PROPOSED TECHNICAL SPECIFICATIONS

## REACTIVITY CONTROL SYSTEMS

### 3/4.1.3 MOVABLE CONTROL ASSEMBLIES

## ATTACHMENT 1

FIGURE 3.1 - 1A

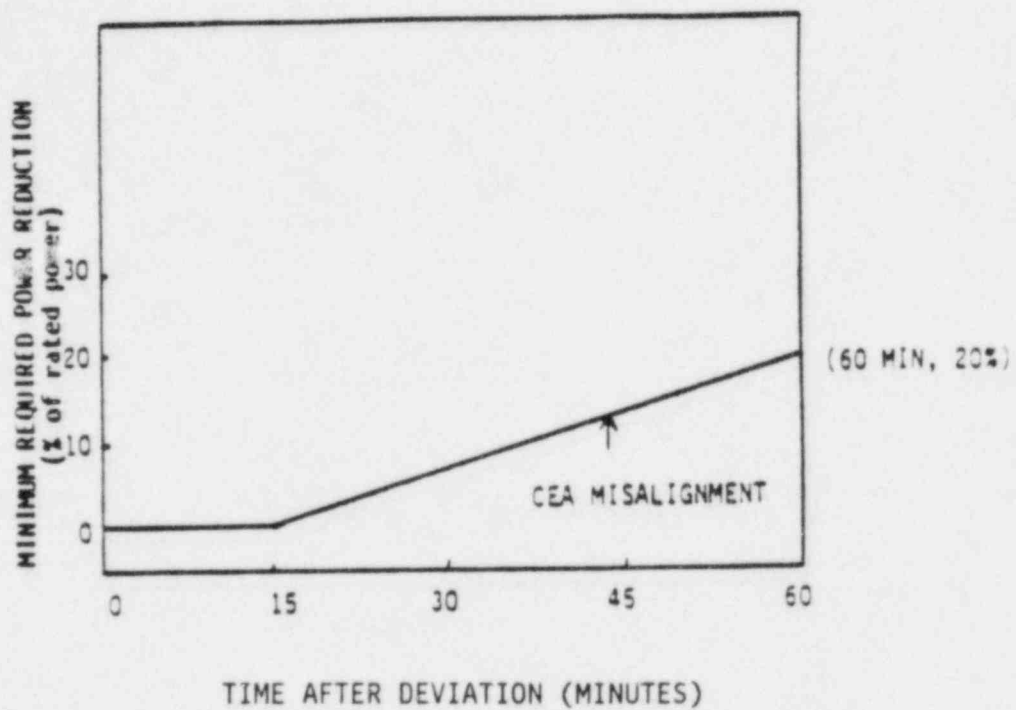
The proposed change revises Technical Specification 3.1.3.1 to require a reduction in core power after a detection of a CEA deviation (i.e., one CEA is inserted 7 or more inches further than the other CEAs in its group) rather than the application of penalty factors in the calculation of DNBR and LPD as required by the existing Technical Specification. The power reduction is in accordance with the new Figure 3.1-1A. Application of the existing penalty factors in the CPC/CEAC software will typically result in a reactor trip when a CEA deviation occurs. The proposed reduction of these penalty factors will require a power reduction by the operator, but may prevent unnecessary reactor trips due to erroneous CEA position indication, electrical noise and actual CEA drops. The proposed change also revises Figure 3.2-4 to ensure that sufficient margin is reserved for the single CEA inward deviation event when the COLSS is out of service.

The proposed change described above may also be considered similar to Example (ii) in that it constitutes an additional limitation, restriction or control not presently included in the Technical Specifications. Specifically, this change requires a power reduction per the new Figure 3.1-1A in the event of an actual CEA inward deviation.

- d. With one or more full length or part length CEAs misaligned from any other CEAs in its group by more than 7 inches but less than or equal to 19 inches, operation in MODES 1 and 2 may continue, provided that core power is reduced in accordance with Figure 3.1-1A and that within one hour the misaligned CEA(s) is either:

- e. With one full length or part length CEA misaligned from any other CEA in its group by more than 19 inches, operation in MODES 1 and 2 may continue, provided that core power is reduced in accordance with Figure 3.1-1A and that within one hour the misaligned CEA is either:

FIGURE 3.2-4

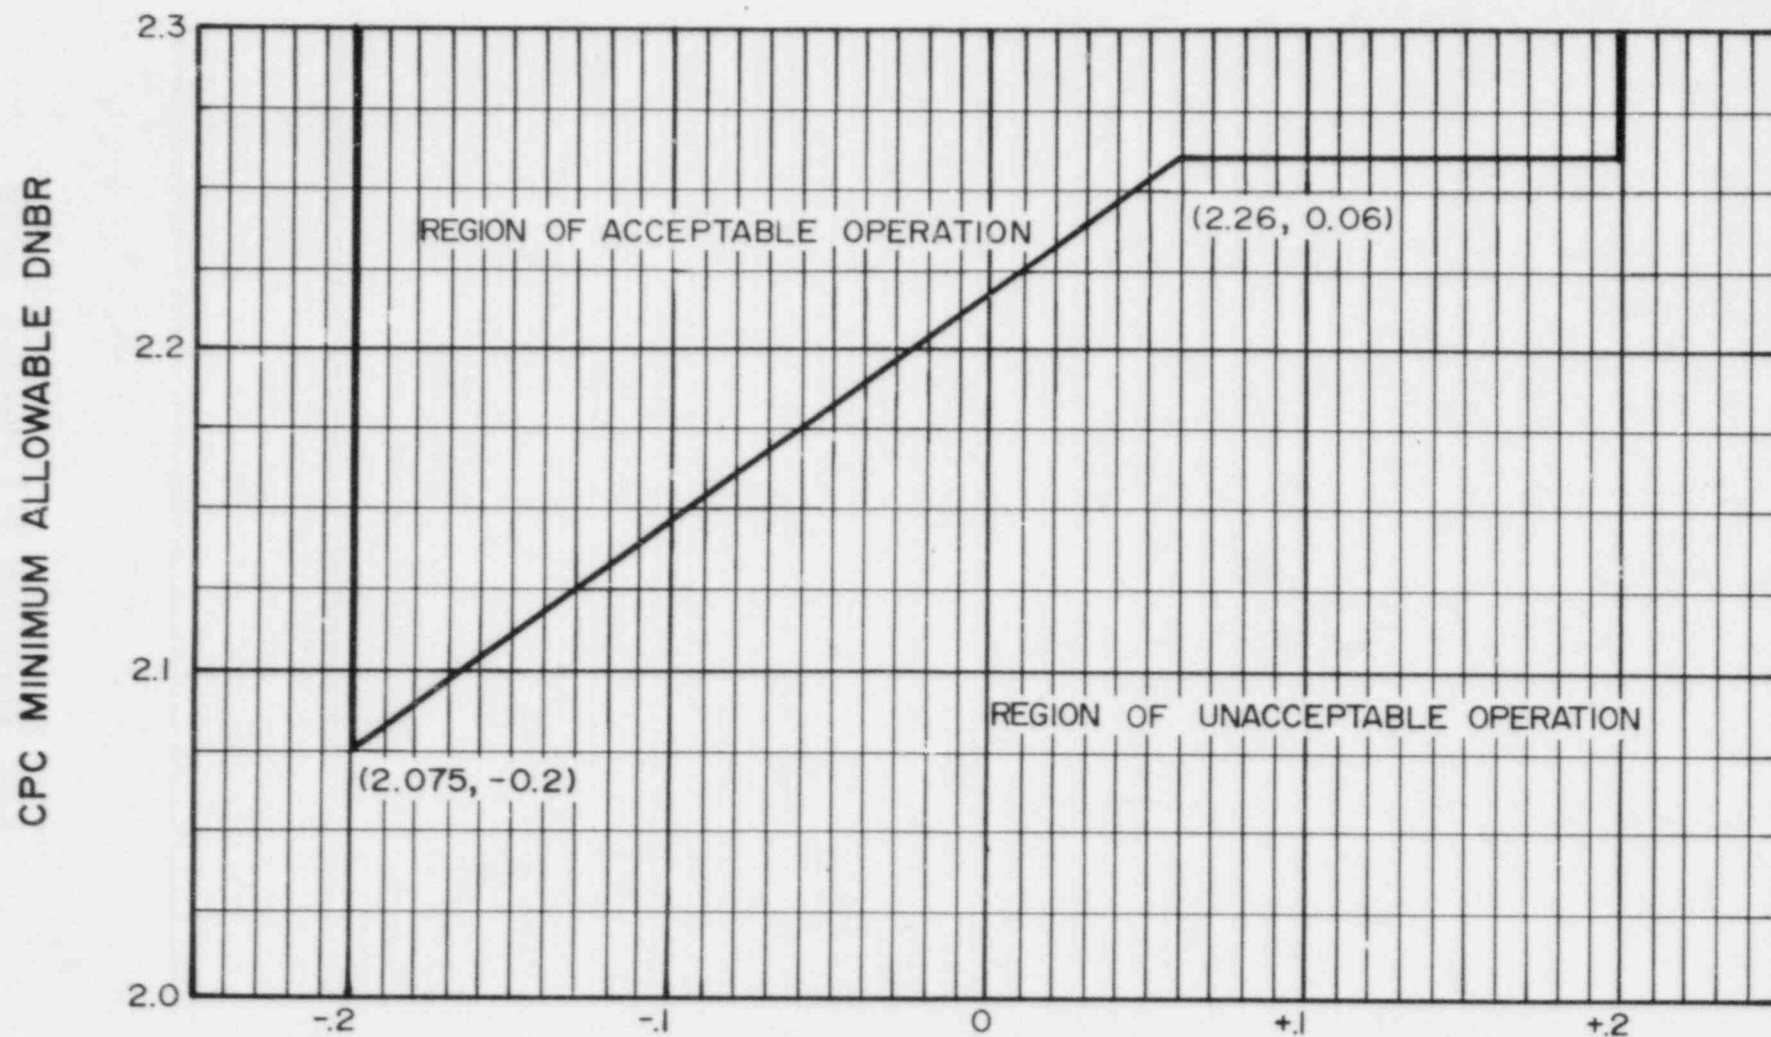
Technical Specification 3.2.4 requires that the DNBR margin be maintained by operating within the region of acceptable operation of Figure 3.2-3 or 3.2-4, as applicable. Figure 3.2-3 specifies the DNBR margin operating limit based on the Core Operating Limit Supervisory System (COLSS). Figure 3.2-4 specifies the DNBR margin operating limit based on the CPCs and is used when the COLSS is out of service.
